**Development Permit Panel  
Wednesday, May 27, 2026**

**1. DEVELOPMENT PERMIT 26-009020  
(REDMS No. 8391830)**

**2. DEVELOPMENT PERMIT 24-048989**

**Landscape Plan**

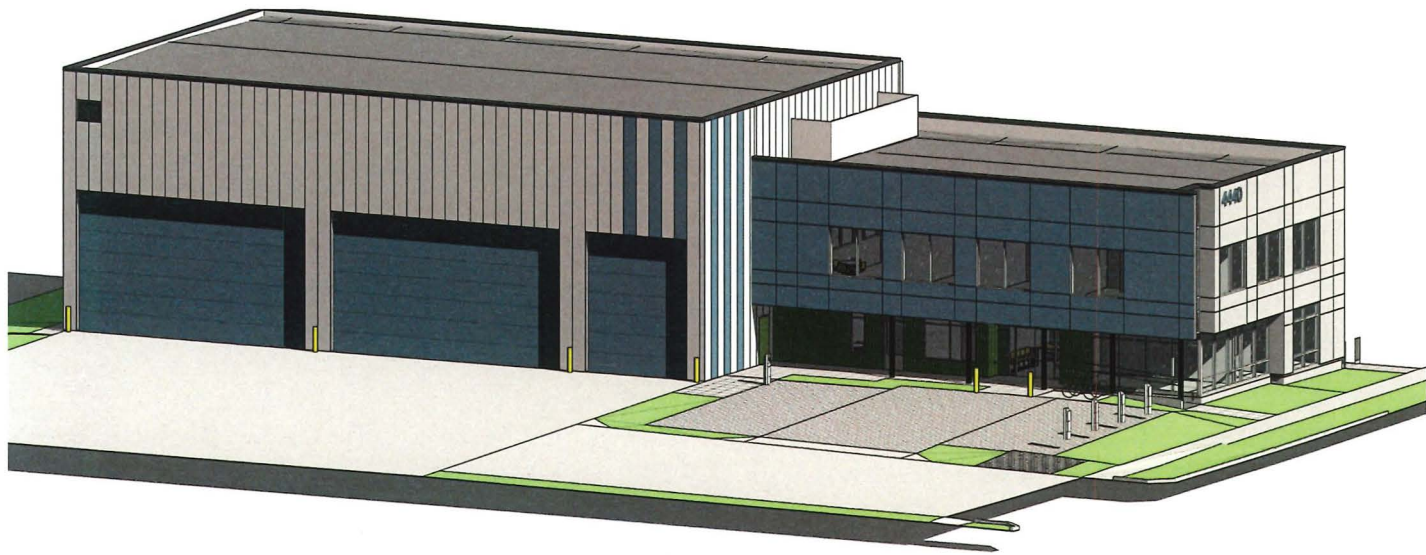
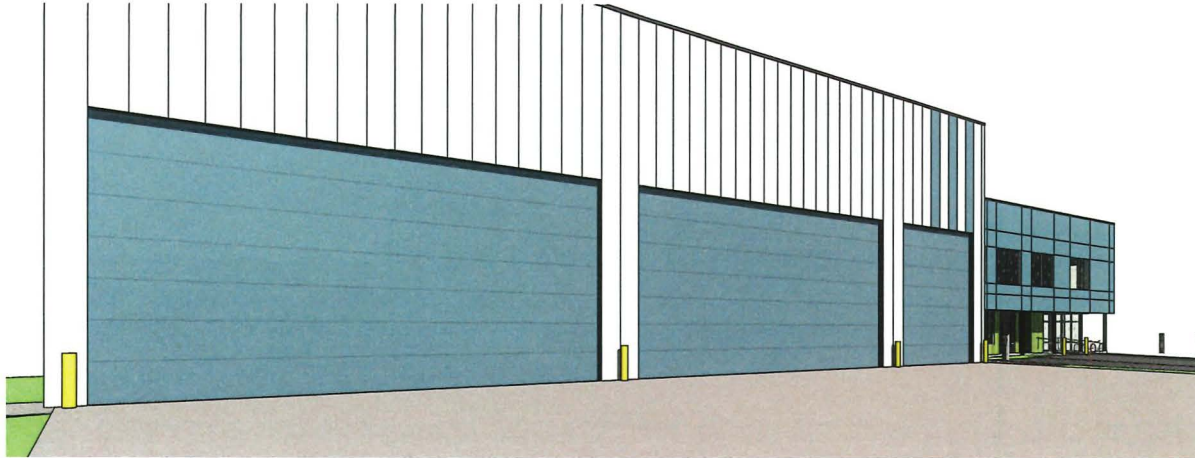
The Panel commented on the choice of landscaping for the subject site and suggested to change the proposed tree in the front yard and replace it with a smaller tree such as a Dogwood or a Magnolia.

In reply to queries from Panel, the applicant noted that (i) the pathway remains on the south-west side of the subject site, and (ii) the proposed front yard tree would be changed to a native dogwood.

The Panel directed staff to work with the applicant to review the location and landscape screening of the heat pump and to review the tree species for the front yard.

**DRAWING TITLE**  
 LANDSCAPE PLANTING PLAN

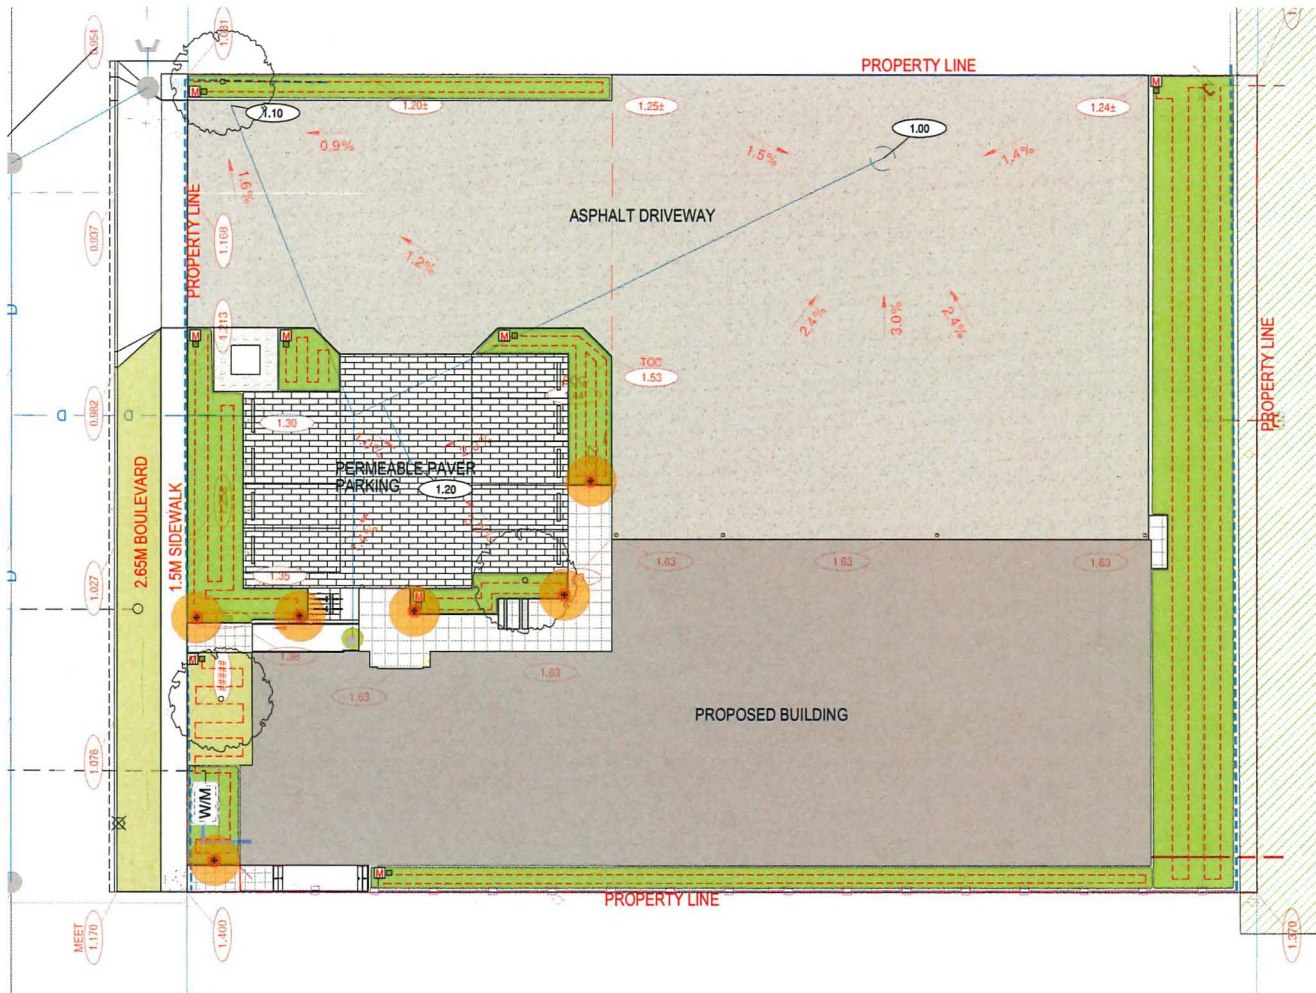
The Panel commented on the landscape proposal for the project site and made suggestions for alternate tree species, sun tolerant shrubs and the use of more durable fencing material.

The Panel directed staff to work with the applicant to review the proposed landscaping.
